Comment Date: January 26, 2012 23:56:11PM
Supplement to the Draft Solar PEIS
Comment ID: SEDDSupp20100

Re: Joint Comments on Supplemental Draft PEIS for Solar Development

Figure 2. Suggested zone for studying the possibility of SEZs in the West Mojave.

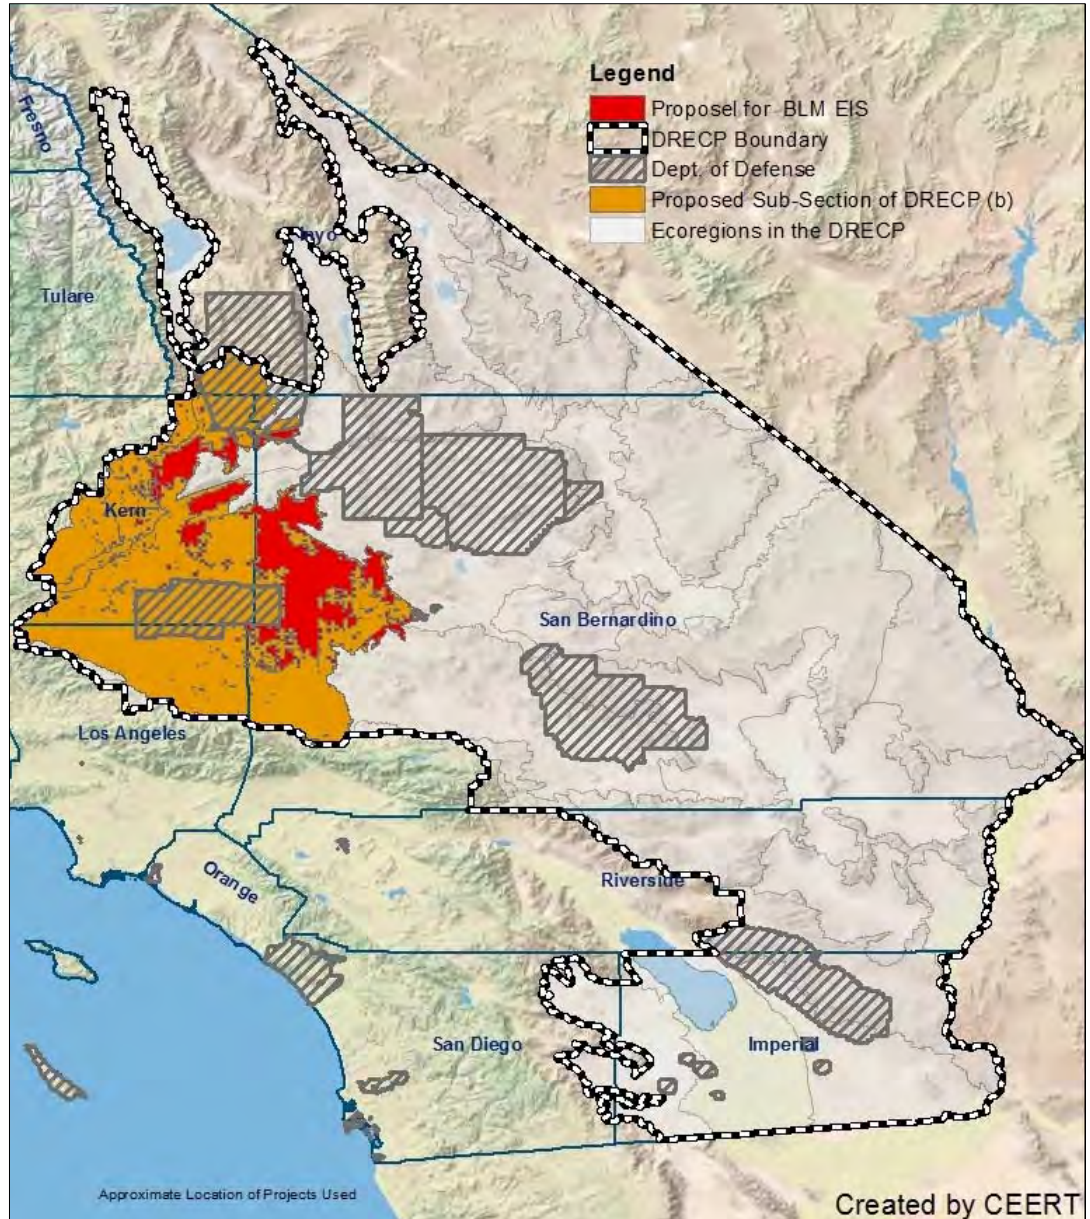
be worthwhile to provide for development opportunities in this region with unparalleled solar resources.

Figure 3. Proposed starting point for SEZ evaluations in the West Mojave.

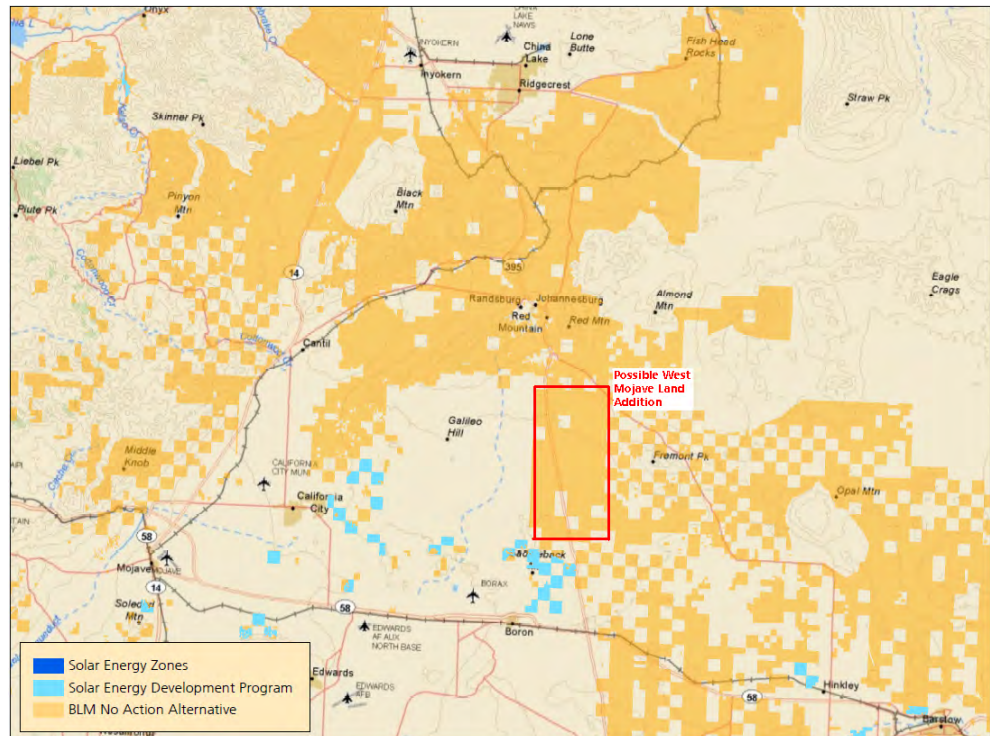
Solution: As stated above, BLM should establish a consistent process for identifying and approving new SEZs or SEZ expansions (assuming, of course, that those SEZs follow the recommendations we have laid out above). Such process will be important if BLM designates SEZs, and BLM should identify that process in the Final PEIS. BLM also should begin evaluating new potential SEZs in the West Mojave, Chocolate Mountains, lands identified in the Arizona Restoration Design Energy Project, and other areas. Figure 3 below depicts one possible area for West Mojave utility-scale solar development.

Originally Proposed Dry Lake SEZ and Old Spanish National Trail

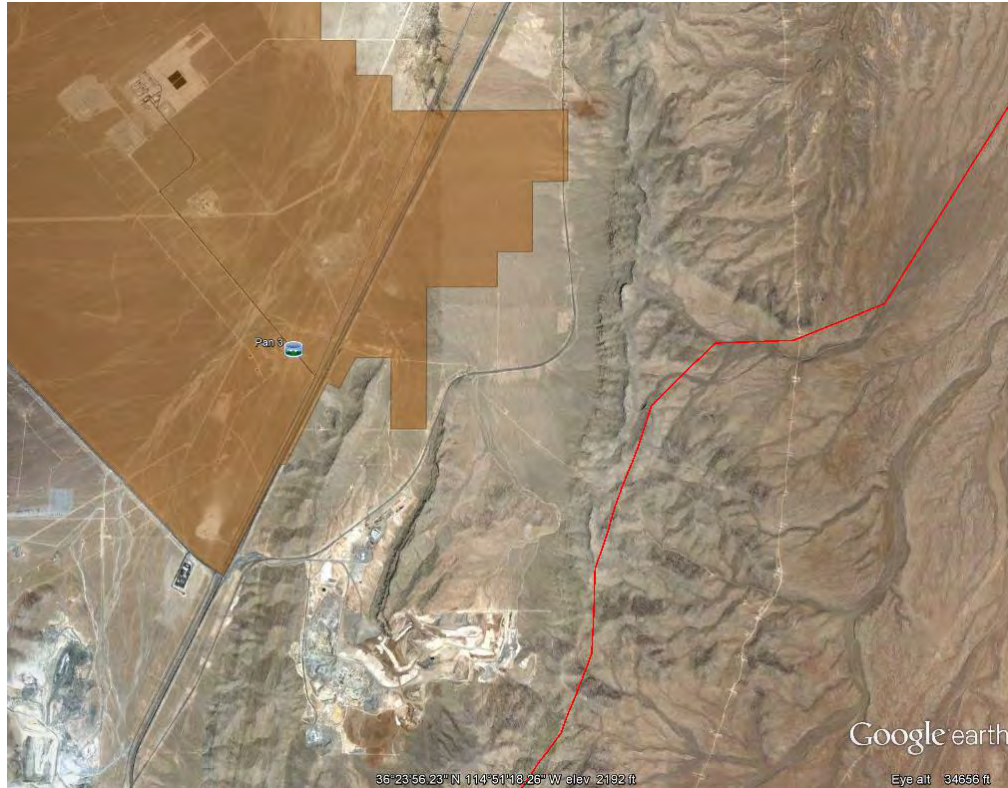
The SDPEIS proposes removing the portion of the Dry Lake SEZ lying southeast of I-15 due to concerns regarding potential impacts to the Old Spanish National Historical Trail.¹¹ However, as the KMZ files for the Draft PEIS attest, this portion of the originally proposed Dry Lake SEZ is almost entirely screened from the Old Spanish National Historical Trail by an intervening ridge of the Dry Lake Range (See Figure 1, below). In addition, the trail turns east and away from the SEZ at approximately the same point it reaches the portion of the original SEZ lying southeast of I-15. Moreover, if a viewer follows the trail at ground level on Google Earth, the few mountain-top locations along the trail where the SEZ can be viewed reveal the SEZ lands *west* of the I-15; lands to the east of the I-15 for the most part remain obscured from view due to their close proximity to the base of the intervening ridge. Figures 2 and 3 below illustrate this effect by showing where the trail is visible (in red) from the I-15 (Figure 2) and from the eastern edge of the original SEZ (Figure 3). Because the lands east of I-15 for the most part cannot be seen from the Old Spanish National Historical Trail (and in fact appear to be less visible than the rest of the SEZ), enXco requests their reincorporation into the Dry Lake SEZ.

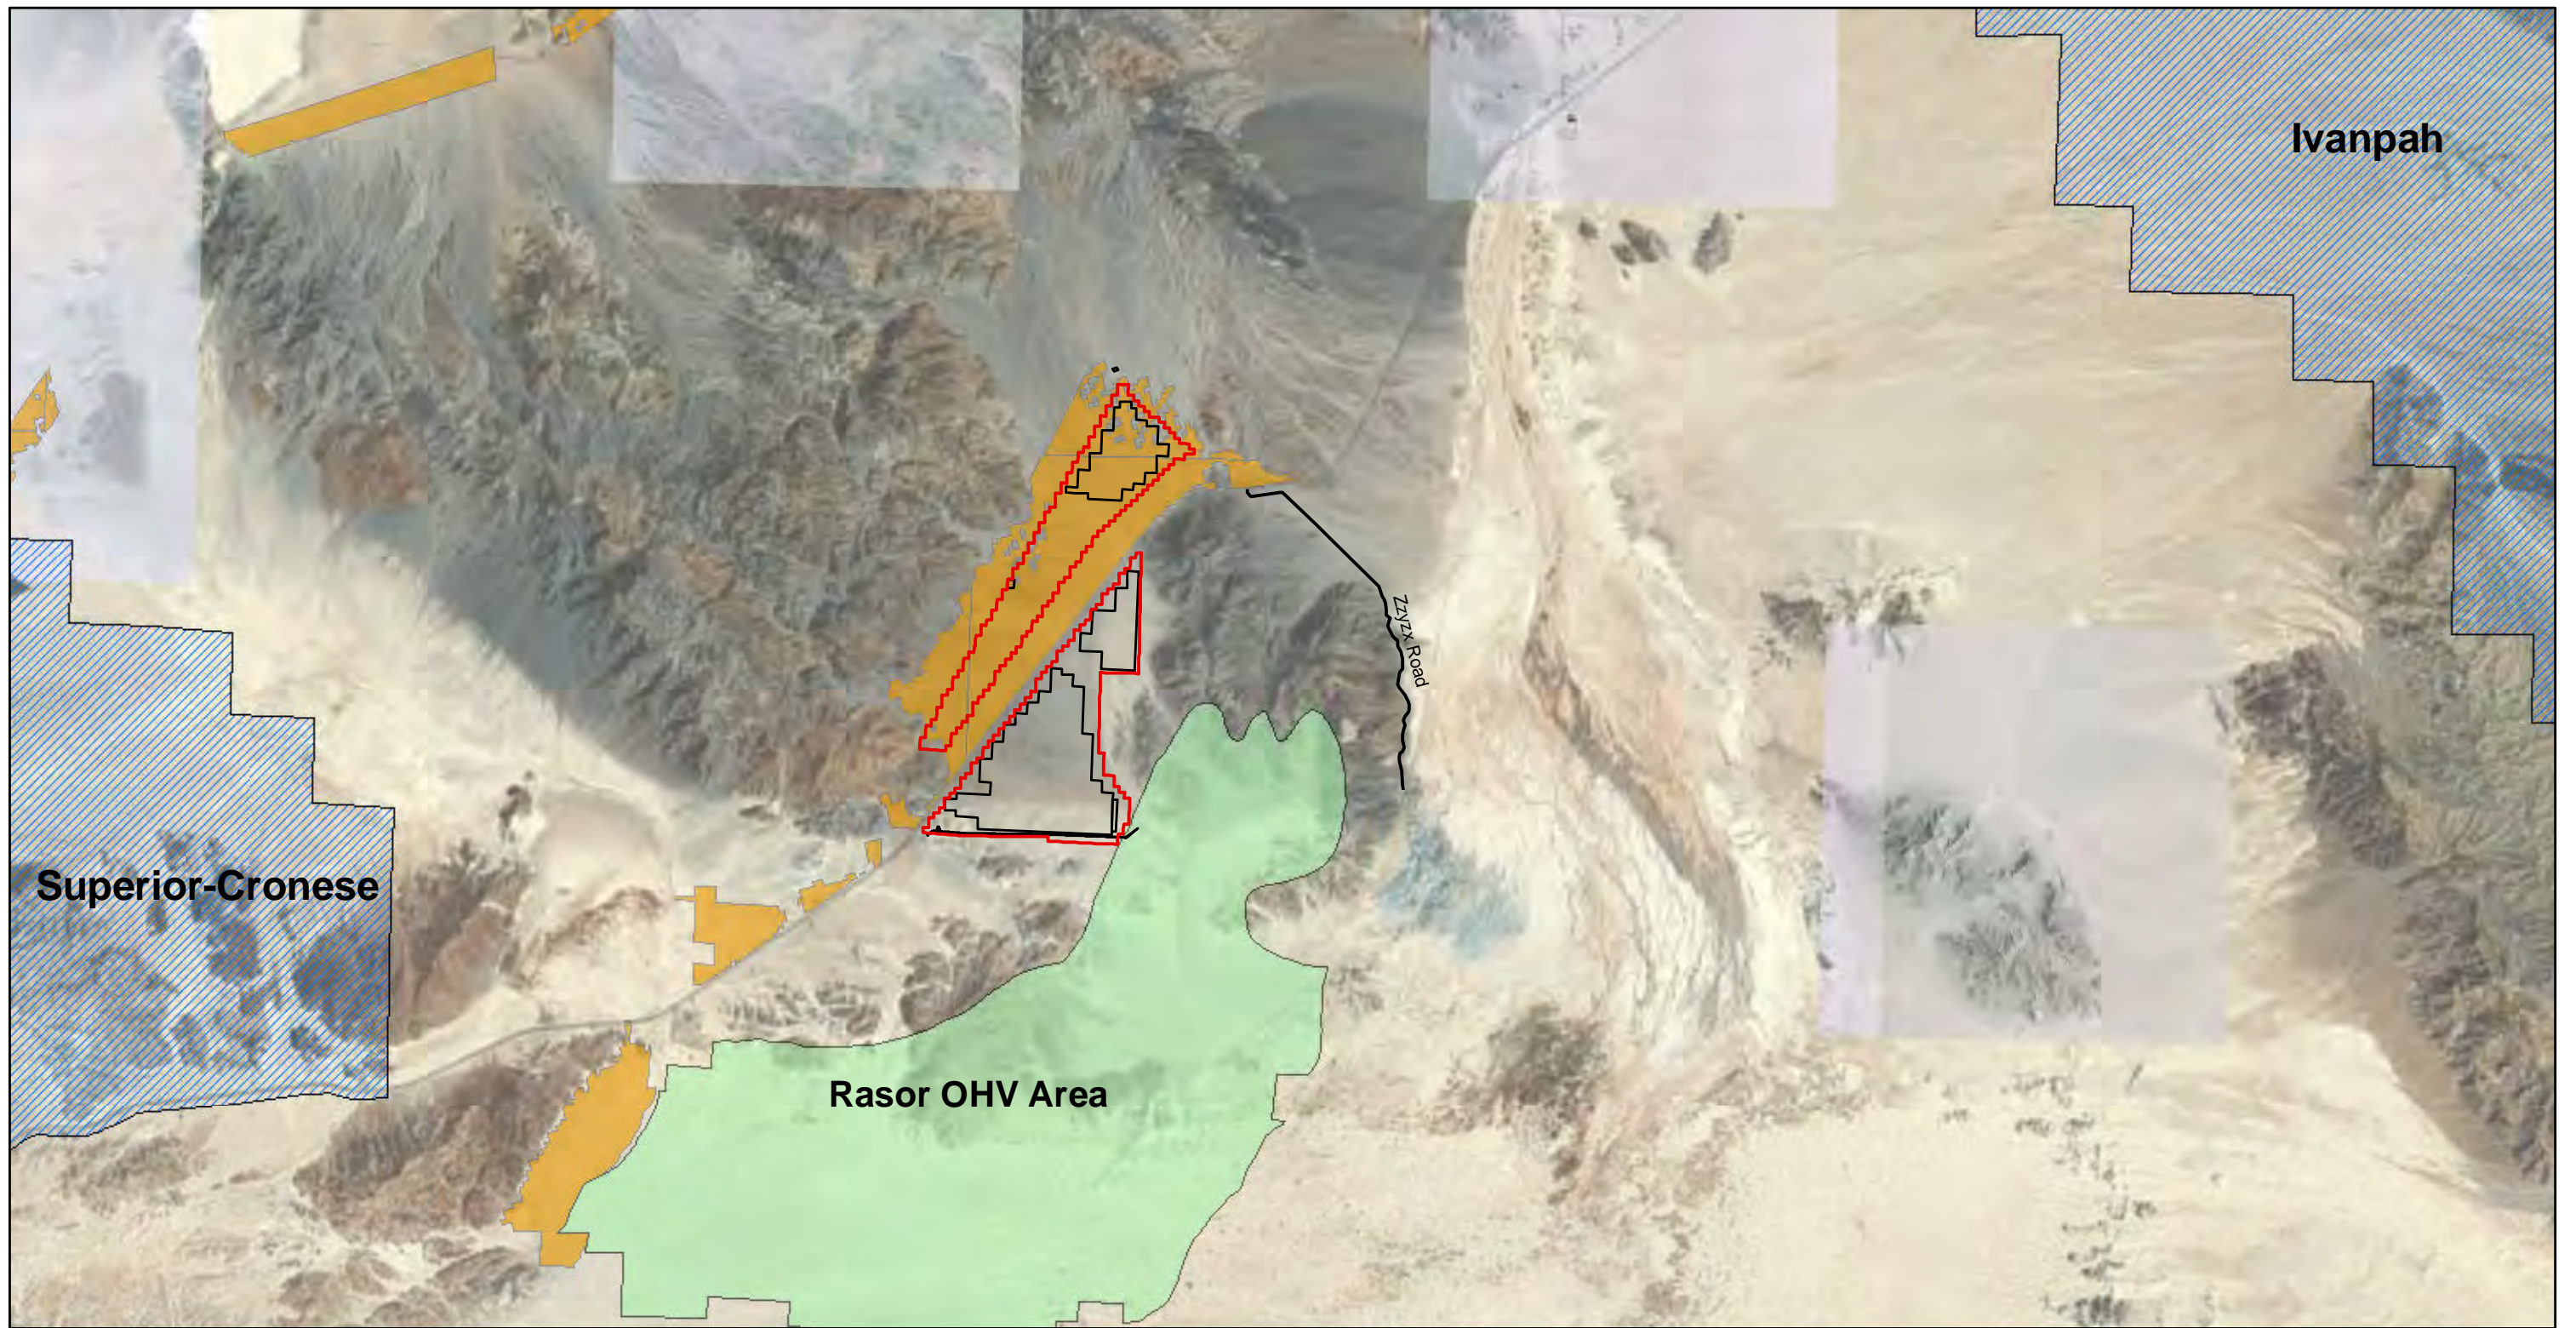
The proposed connectivity area in the Soda Mountains area is surrounded by barriers to tortoise movement. Figure 1 shows the topography of and around the proposed connectivity area. The south and east portion of the connectivity area is bounded by I-15, which serves as an effective barrier to tortoise movement to the south and east, as does the Razor Road Off Highway Vehicle Area (Figure 2). The Soda Mountains surround the proposed connectivity area and serve as a barrier to tortoise movement from the connectivity area to the north, east and west. Moreover, Baker Sink, part of a north-south low topography feature and desert wash complex located to the east of the connectivity area, and Soda Lake, the dry playa Baker Sink drains into, have also been identified as areas of low potential for tortoise occurrence (Hagerty et al. 2010). In

The SDPEIS includes a map depicting "Desert Tortoise Conservation Areas and Proposed Connectivity Areas." (SDPEIS Figure 2.3-1, page 2-44). We request that the proposed connectivity area overlaying the Soda Mountain Solar Project in the valley between the Soda Mountains south of Baker, west of the Mojave National Preserve (MNP), be removed for the following reasons:

Figure 2: Land Use

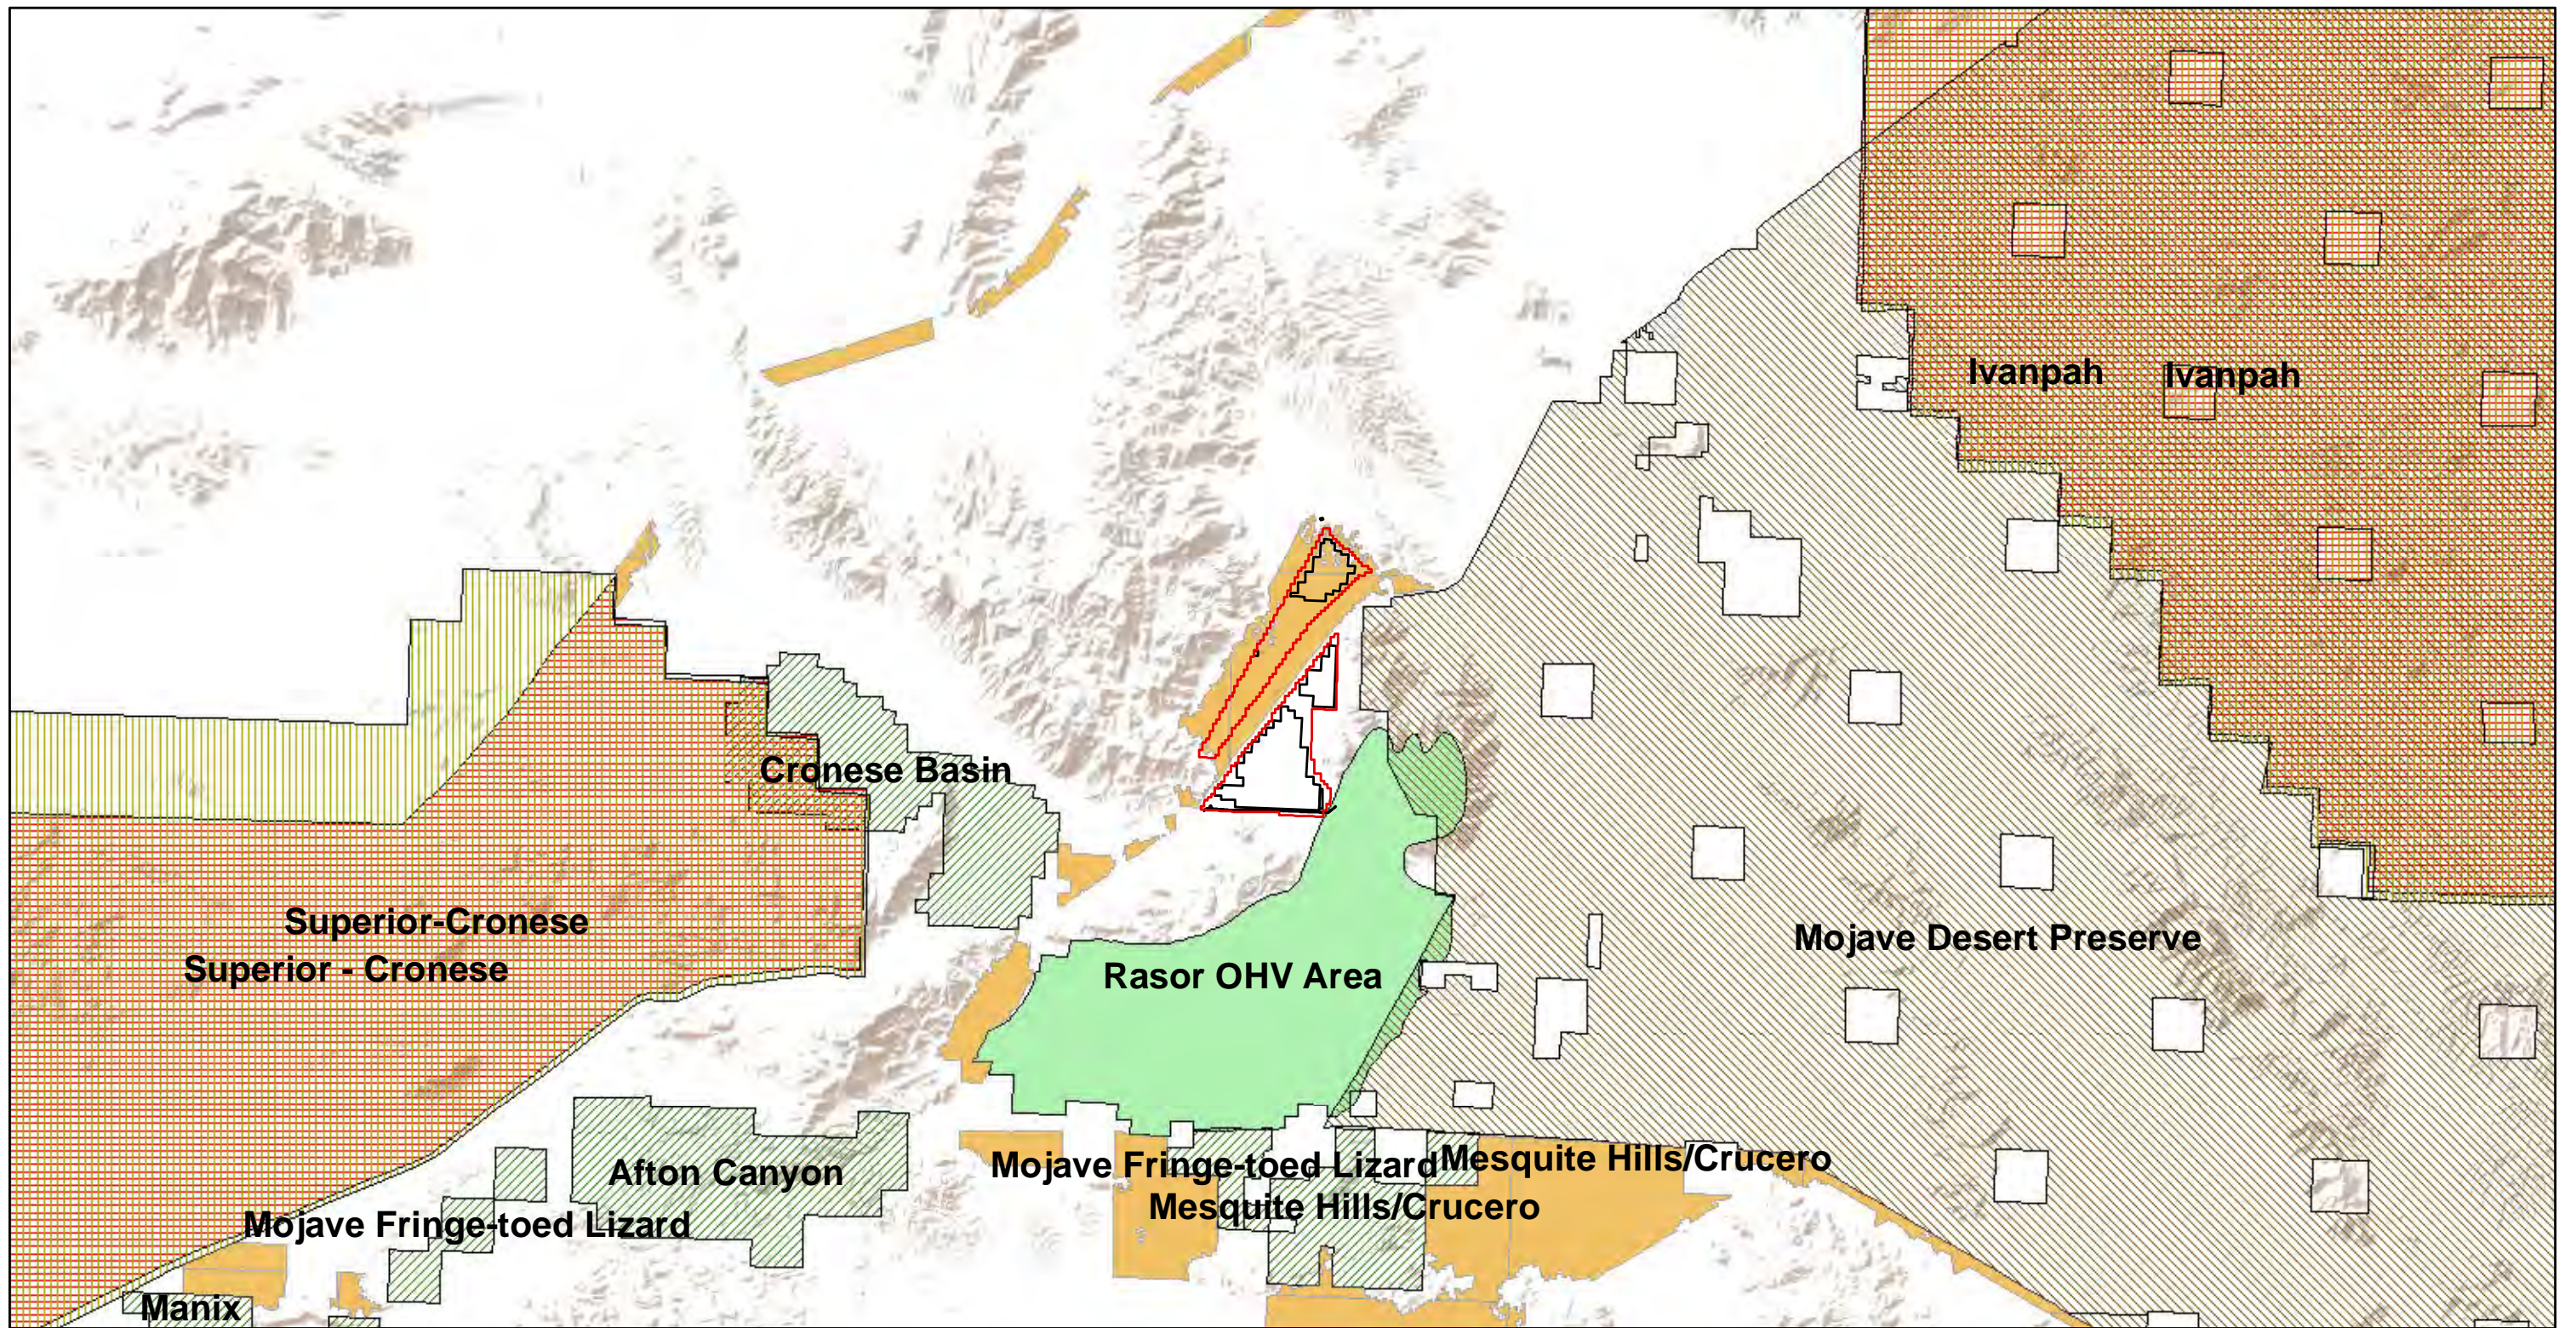
But for the barriers mentioned above, the proposed connectivity area might seem to be a logical corridor to the MNP because of its proximity, and it is on this basis that the proposed connectivity area appears to be drawn: to provide connectivity northwards from the Cronese Basin Area of Critical Environmental Concern, through the portion of the Soda Mountain Solar Project site lying to the northwest of I-15, and then eastwards under I-15 and into the MNP (Figure 2).
